International
Aero Engines

SERVICE BULLETIN

SB No. V2500-NAC-78-0105

**NACELLE - EXHAUST - BOLT CUPS, EXHAUST CONE - INSTALLATION
OF DOUBLERS; REWELD OF**

Cone Assembly Bolt Cup Doubler Installation
Figure 1

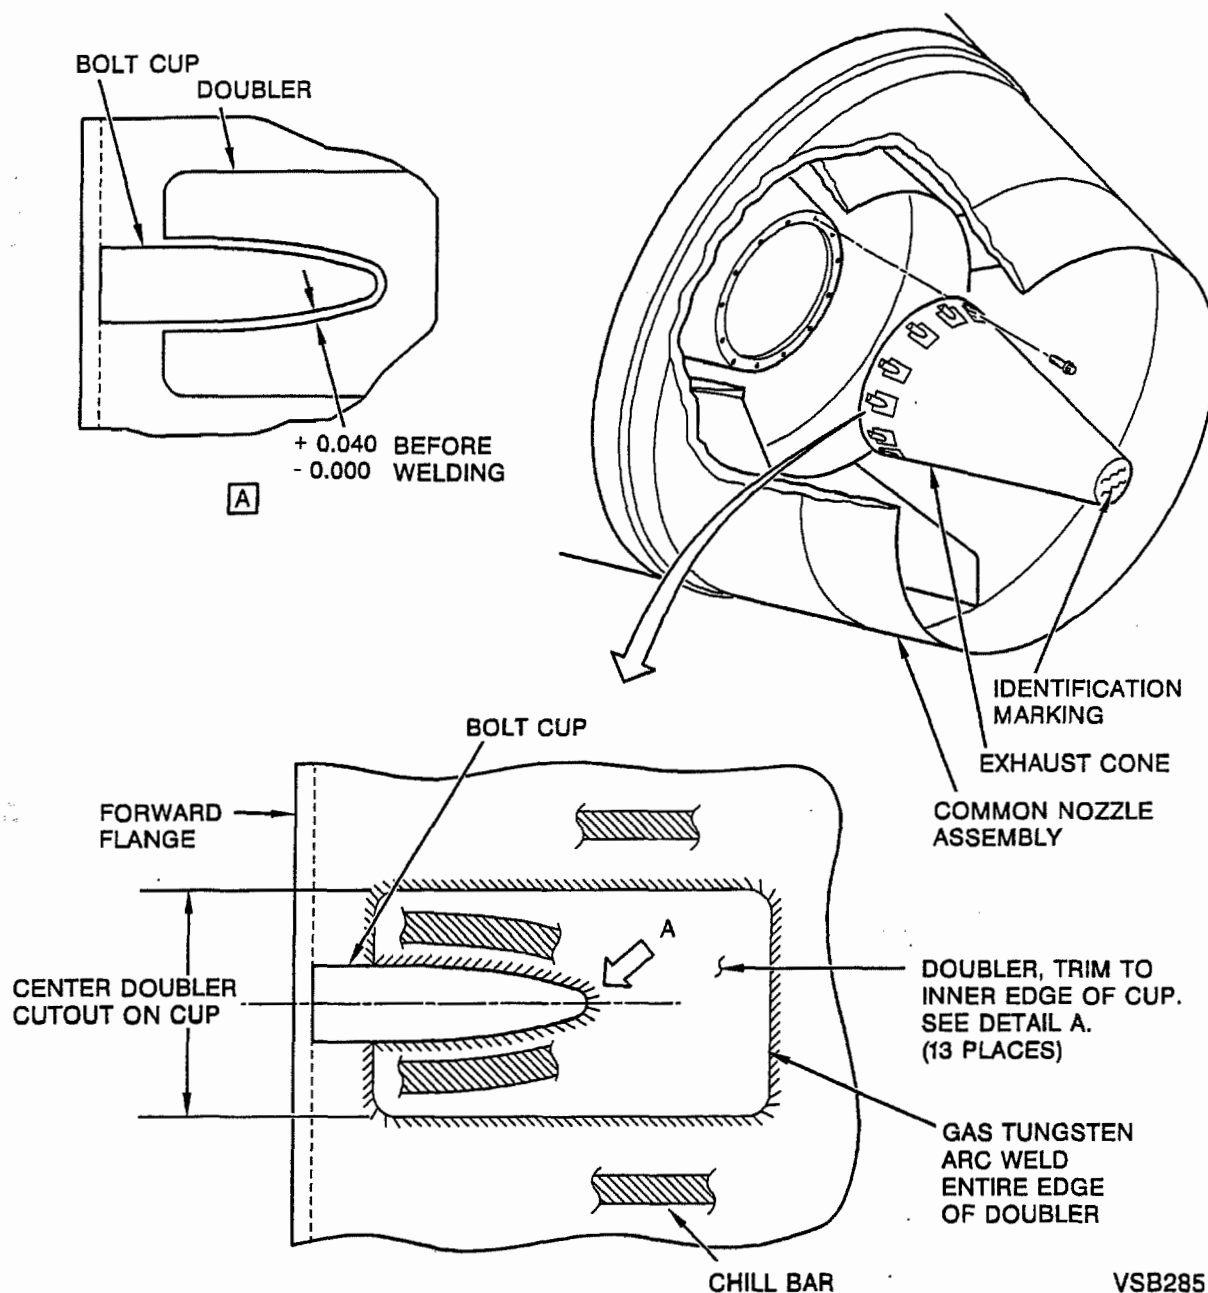
- (1) Cut doublers as required to fit around bolt cups. Refer to Figure 1 to make sure of correct placement of doubler around bolt cup cutout.
- (2) Put the doublers around the bolt cups. Bend doublers to align with tail cone assembly contour. Make sure doubler makes a continuous surface with tail cone assembly for welding.
- (3) Remove oxides/contaminates from weld areas with a stainless steel wire brush.

- (5) Put the doublers around the bolt cups and weld in position. Refer to V2500 Standard Practices/Processes Manual, Chapter 70-31-13. Use CoMat 03-287 welding filler wire (AMS5837). Use copper chill bars around the weld areas to decrease heat in weld area.

BOLT CUP PREPARATION FOR RE-WELDING
FIGURE 2

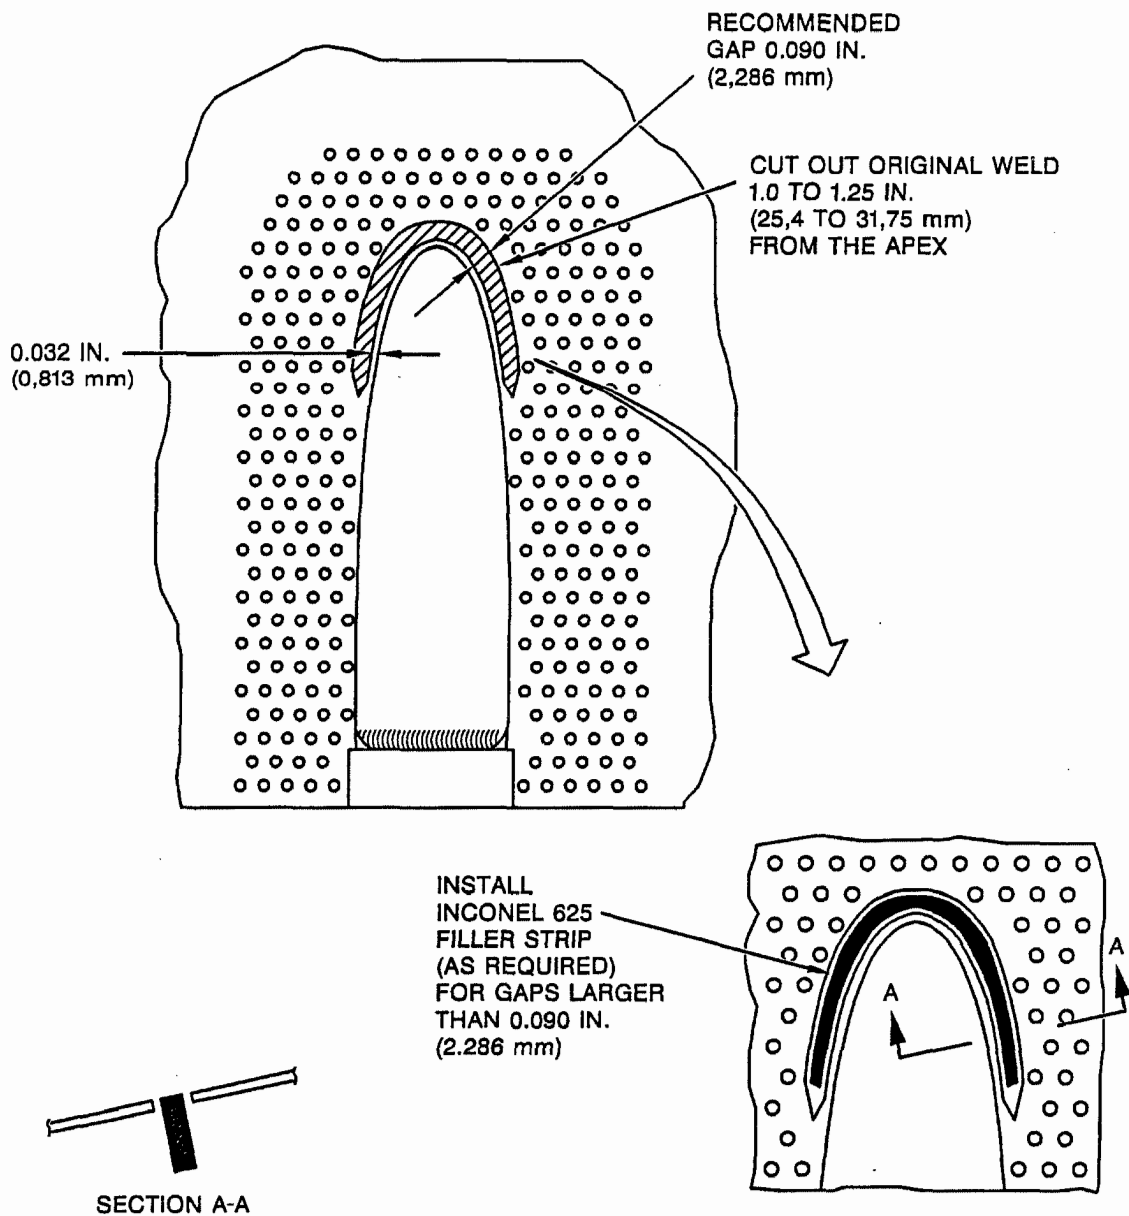
- (3) Cut the existing weld with a hand motor and cutting disk. The edge of the cut should be at least 0.032 inch (0.813 mm) away from the edge of the cup, to prevent thinning of the cup below the surface of the exhaust cone and no wider than .090 inch (2.286 mm). The cut should extend 1.0-1.25 inches (25.4-31.75 mm) on each side of the apex. See Figure 2.
- (4) Trim any remaining material at the apex of the cup with a drill or hand held motor and small diameter router bit. The finished cut should appear as shown in Figure 2.

RECOMMENDED HEAT SINK CONFIGURATION
FIGURE 3

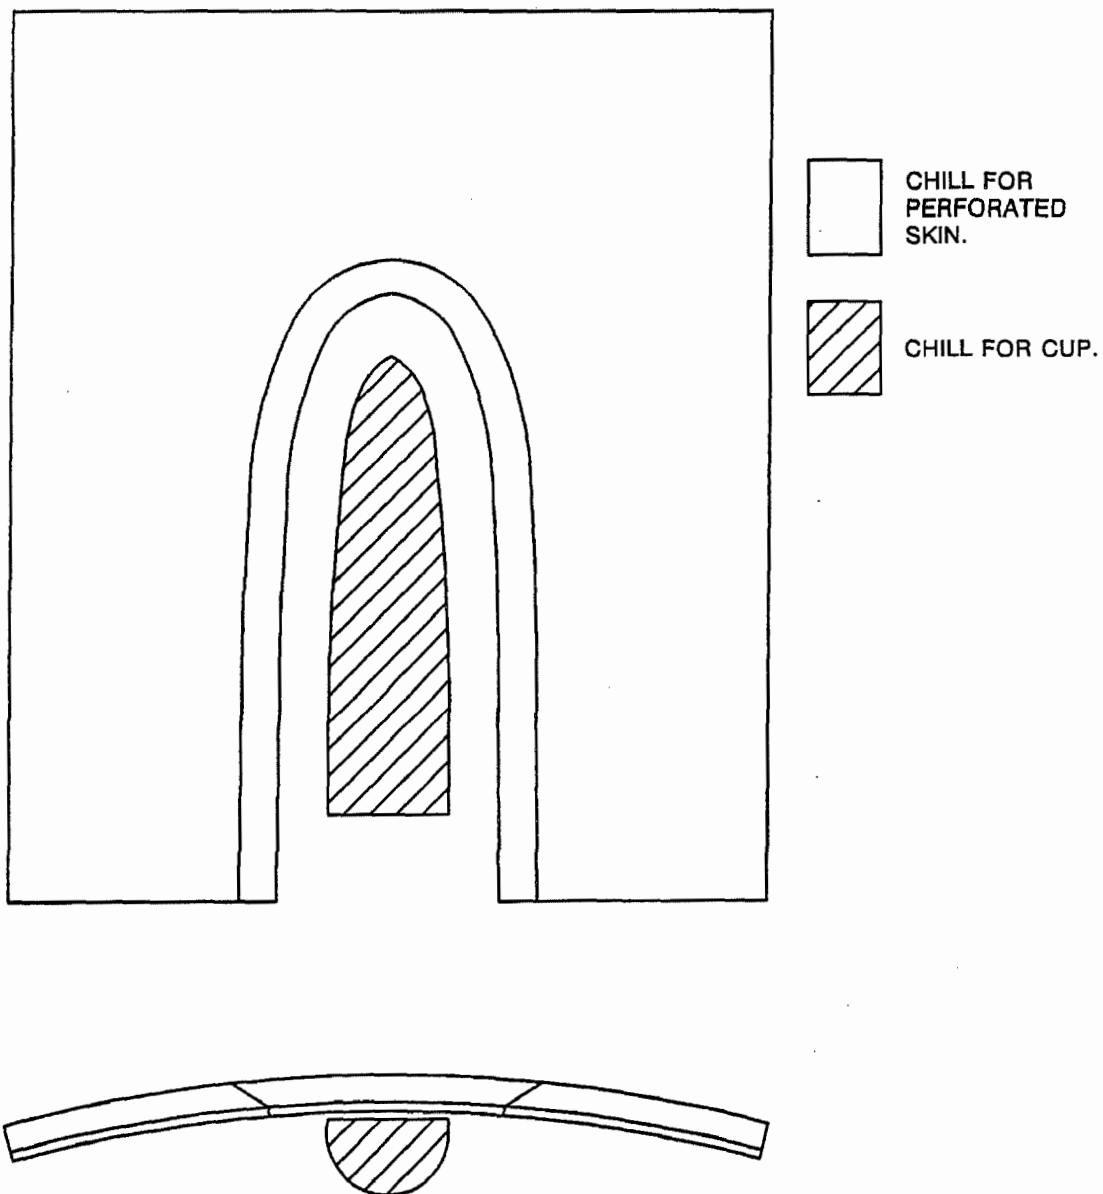
- (5) Fabricate an (CoMat 03-287) Inconel 625 filler strip, to be placed in the cut out slot, allowing the weld to bridge the gap between the cup and the perforated skin.
- (6) Use a clean (CoMat 02-099) lint-free cloth and (CoMat 01-001) 1.1.1. trichlorethane to clean area around cups.
- (7) Place a copper heat sink on the surface of the exhaust cone, adjacent to the rework area, and insert a copper heat sink in the cavity of the cup. The heat sinks must be in contact with the part to be effective. Attach the heat sinks with clamps or tape. Take care to keep any tape or adhesives away from the weld area. The recommended heat sink configuration is shown in Figure 3.

WELDING SEQUENCE
FIGURE 4

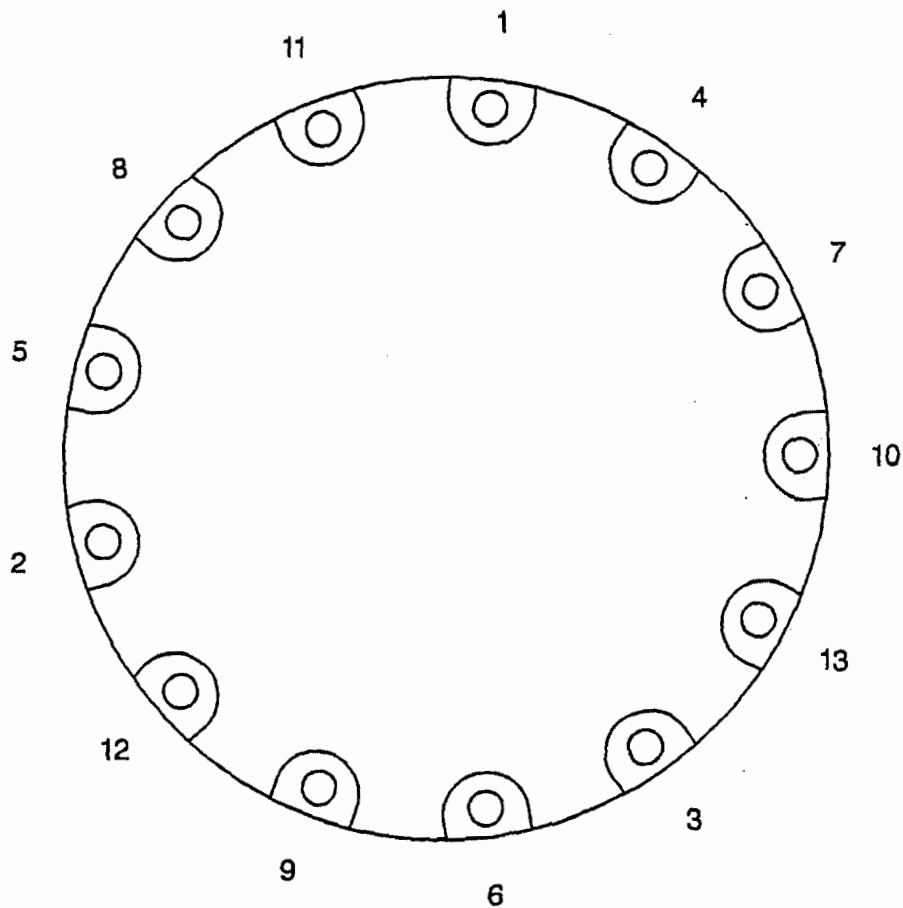
- (8) Fusion weld the cup using the gas tungsten arc welding process (GTAW). Start the weld at the apex of the cup, moving toward the flange. Weld the entire length of the cup including the area left un-cut. Repeat the procedure for each side of the cup. Add (CoMat 03-287) Inconel 625 filler wire as needed to fill the gap and produce a smooth weld crown (face side weld bead reinforcement). Refer to the Standard Practices/Processes Manual, Chapter 70-31-13.
- (9) Repeat the welding process for each cup in the sequence shown in Figure 4 to prevent heat distortion of the exhaust cone.
